**LAKE PONTCHARTRAIN, LA.
AND VICINITY
LAKE PONTCHARTRAIN
HIGH LEVEL PLAN**

**DESIGN MEMORANDUM NO. 19A
GENERAL DESIGN**

**LONDON AVENUE
OUTFALL CANAL
ORLEANS PARISH**

CELMV-ED-PG (CELMN-ED-SP/14 Feb 89) (1105-2-10c) 1st End Mr. Burttschell/jl/7246
SUBJECT: Lake Pontchartrain, Louisiana and Vicinity, High Level Plan,
Design Memorandum No. 19A - General Design, London Avenue Outfall Canal

PLATE 52

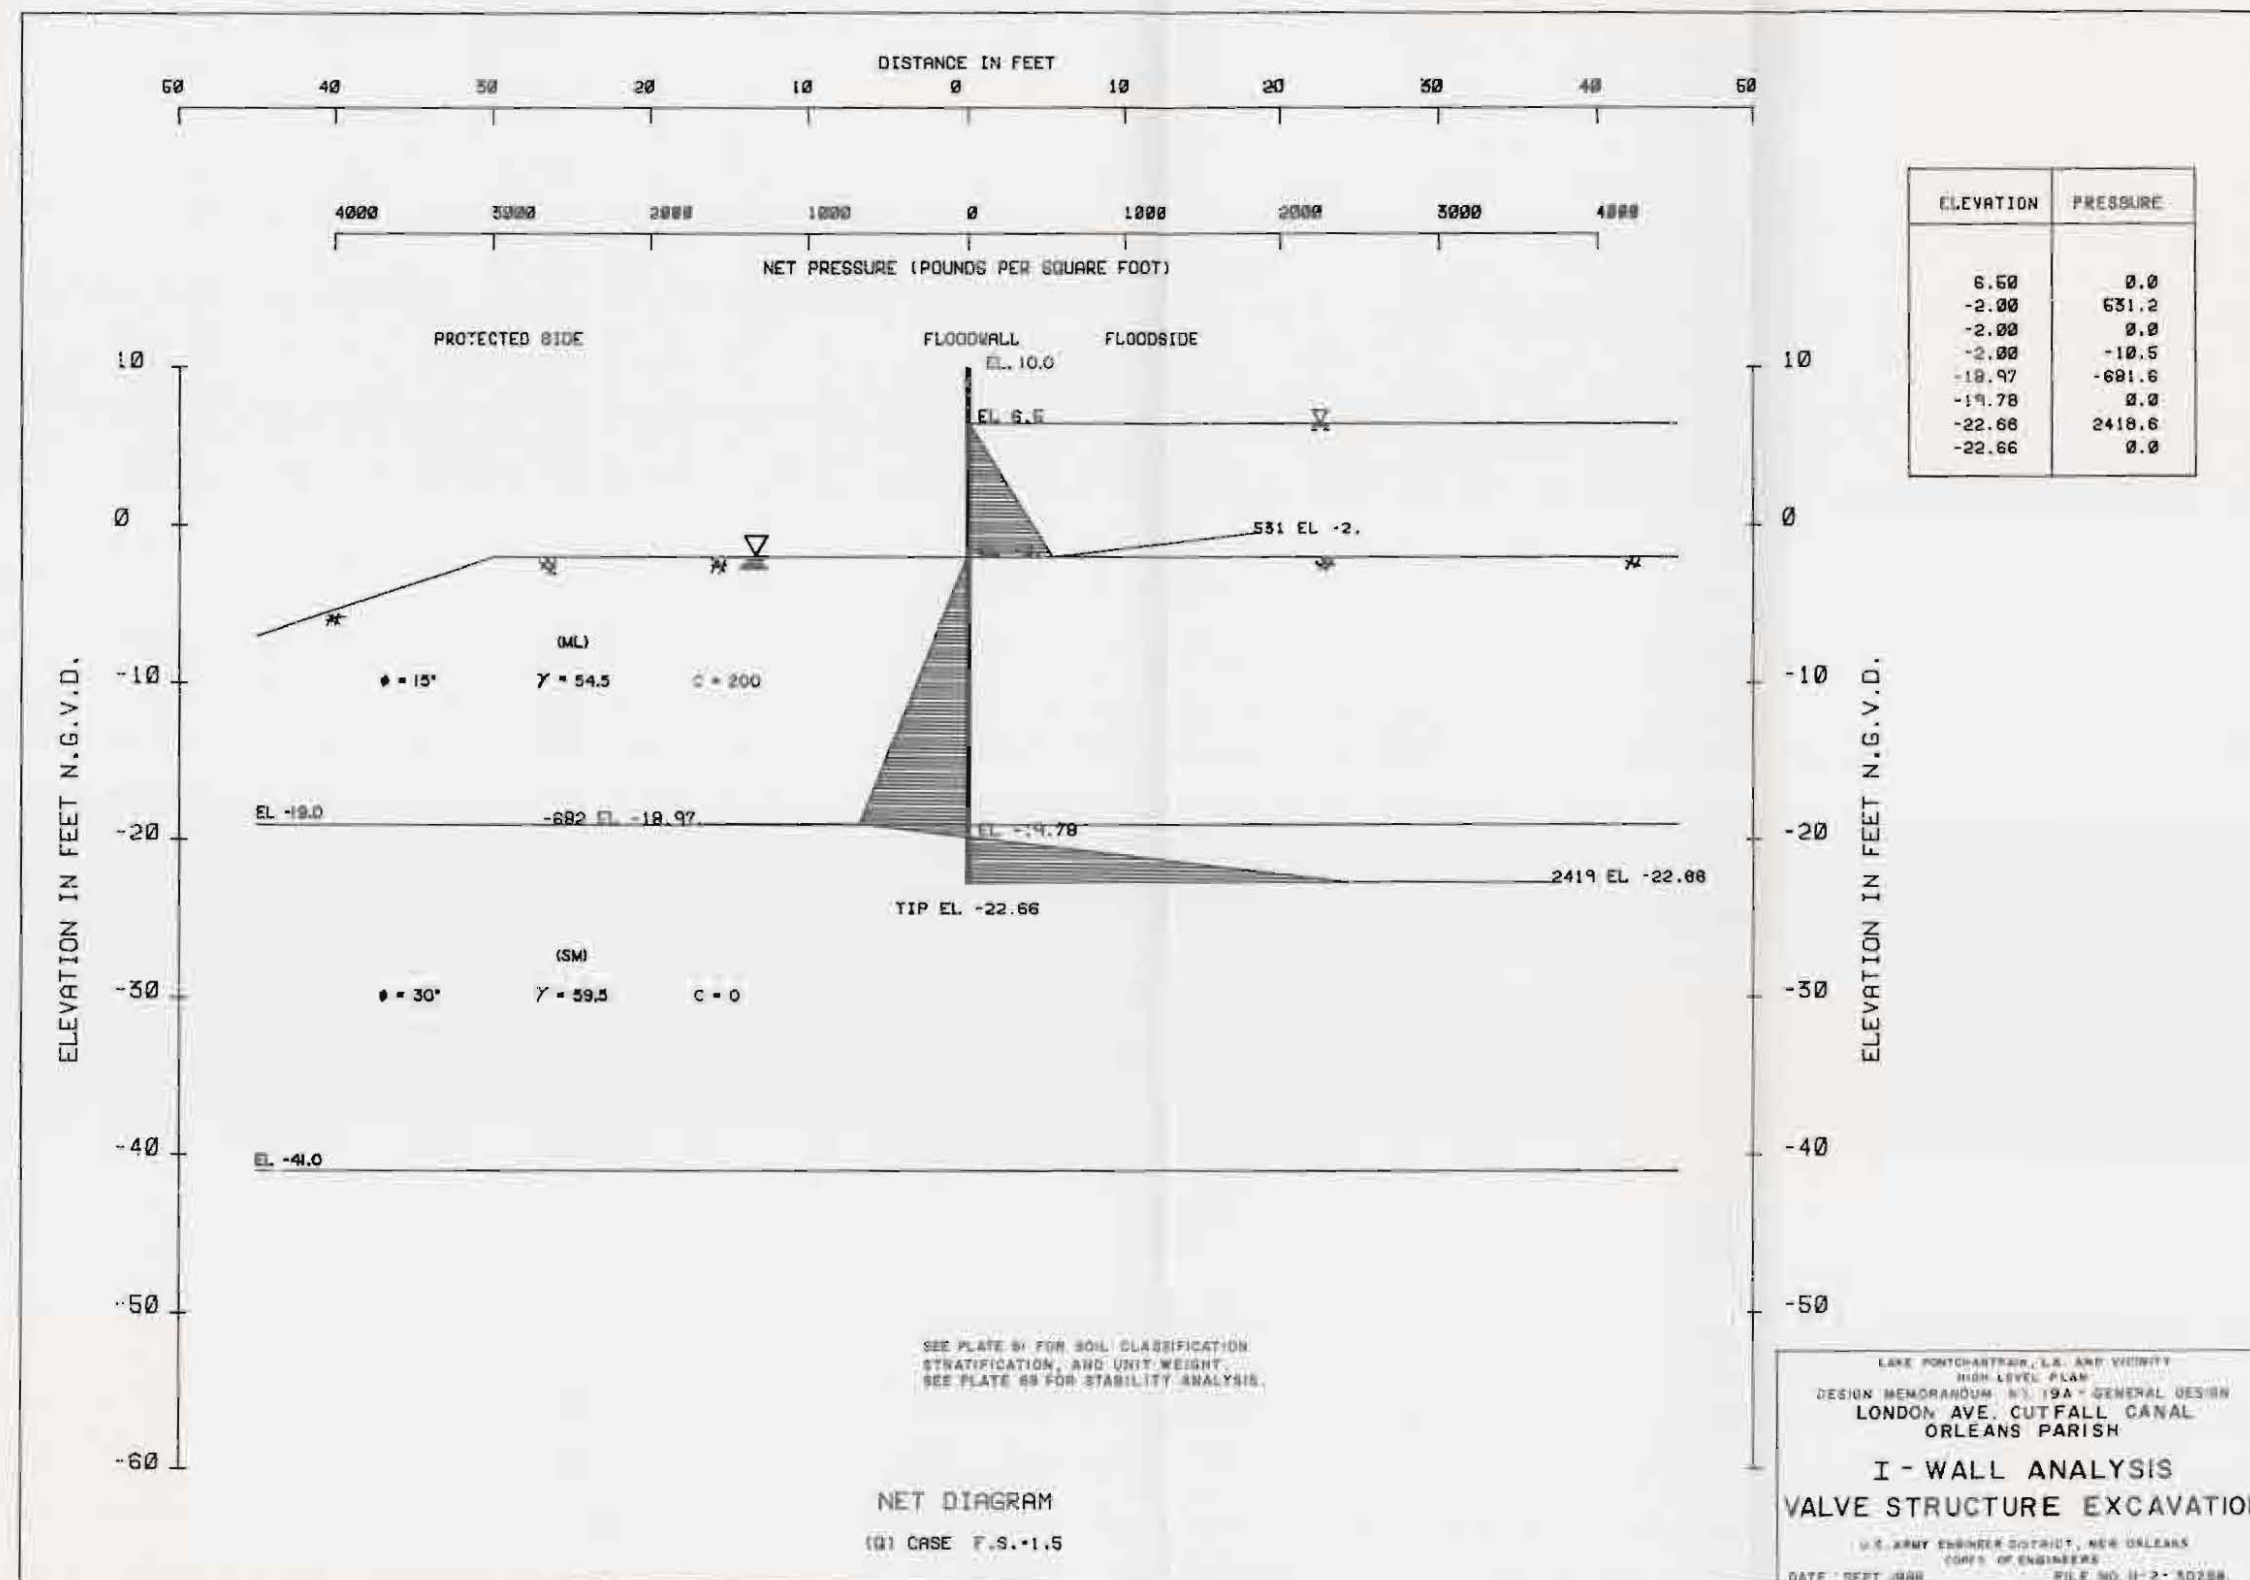
i. Plates 42-94. These I-wall analyses assume all sand levee and foundation soils. However, the borings through these reaches (see Plate 39) show silt and clay layers in the levee and foundation. In the DDM, these plates should be revised to utilize the most conservative stratification for the I-wall stability analyses.

i. Plates 42 - 94. (Should be plates 92 - 94). For plate 92, the only boring in that reach is boring 33 which consists of fine sands from the ground surface to EL - .3 (levee embankment), and a fat clay layer 4.5 ft. thick overlying 13 ft. of sands. Altering the stratification to include the fat clay will not change the I-Wall stability (tip EL +.7) Plate 93 is the start of the transition from the canal levee to the lakefront levee. Boring 34 is the nearest boring to the start of the transition. The stratification of boring 34 is clayey sand to EL -1.5 (levee embankment) overlying a 10 ft. thick layer of fat clay. Changing the stratification from (SM) to (SC) will not change the I-Wall stability (tip EL -.4). The foundation sands on both plates will be changed to clays, but the change will not affect either plate 92 or 93. For plate 94, we concur the stratification will be altered in the DDM to reflect the clays and silts shown in borings 1-ULP, 1-LP and 35. The stationing in the DDM for the geological profile and borings will also include the structure B/L.
